AGENDA PORTLAND PLANNING BOARD MEETING

To: Chair Stanley and Members of the Portland Planning Board
From: Matthew Grooms, Senior Planner
Date: March 22, 2022
Re: UNE request for IOZ designation: Draft Institutional Development Plan (IDP)
Applicant: The University of New England (UNE)

2 EAST ELEVATION (MECHANIC ST)
SCALE: 1/4" = 1'-0"

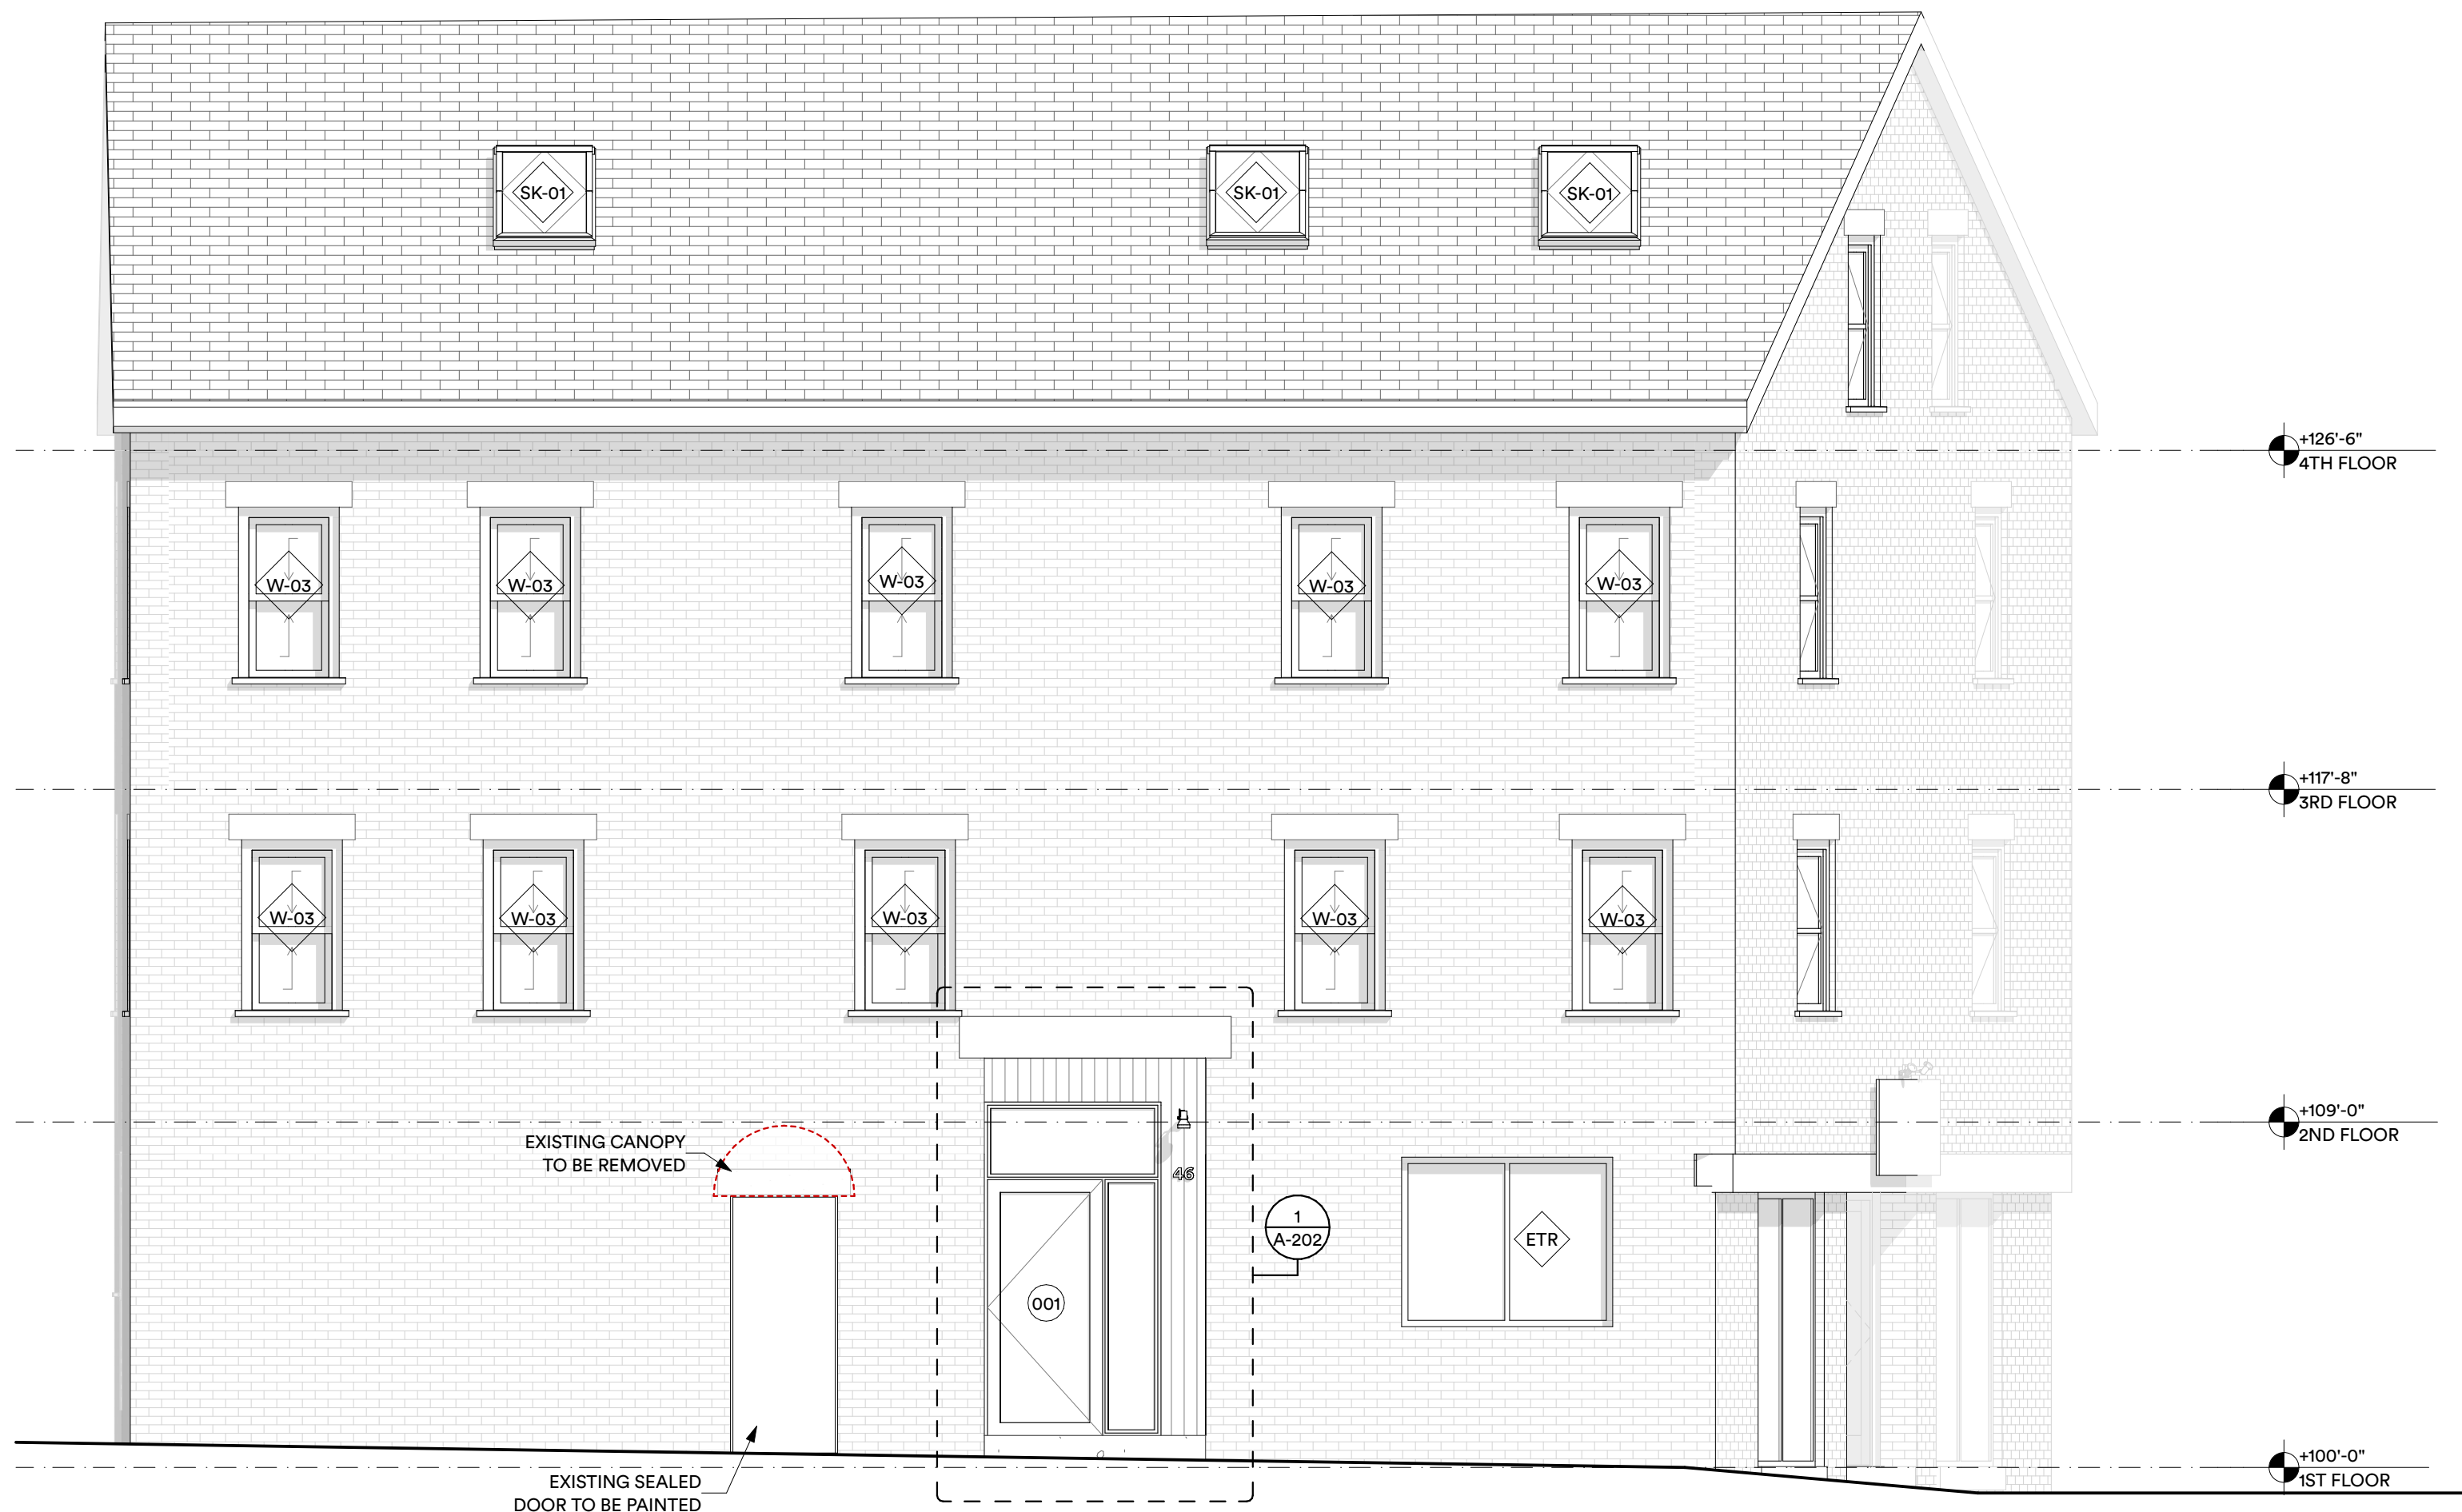
- **Windows - Not Met.** Windows shall be located in all building facades visible from the public way, especially on building facades along the major public street. Applicant to provide window and door schedule and include all existing fenestrations along Mechanic Street as it appears there is a service door and window for venting south of building entry.
Please see updated sheet A-601 for additional information on Doors and Windows. Window for venting has been removed and infilled with new brick masonry as part of the commercial tenant fit-out.

- **Building Character, Detail, Scale, and Graphic Qualities - Not Met.** Building design will include various architectural and graphic amenities to provide a strong presence along a street and relate a building to its community. Applicant to provide materiality of renovated building entry, existing wood paneling appears to be in disrepair.
See sheet A-202 for additional information on tenant entry. New material at resident building entry to be thermally modified wood siding for long term durability.

Windows shall be located in all building facades visible from the public way, especially on building facades along the major public street. Applicant provided window and door schedule on revised drawing sheet A-601 that meet VT of .7 or greater along Mechanic Street street frontage.

Building design will include various architectural and graphic amenities to provide a strong presence along a street and relate a building to its community. Applicant provided entry elevation on new drawing sheet A-202 to include new materiality and window schedule that meet VT of .7 or greater along Mechanic Street street frontage.
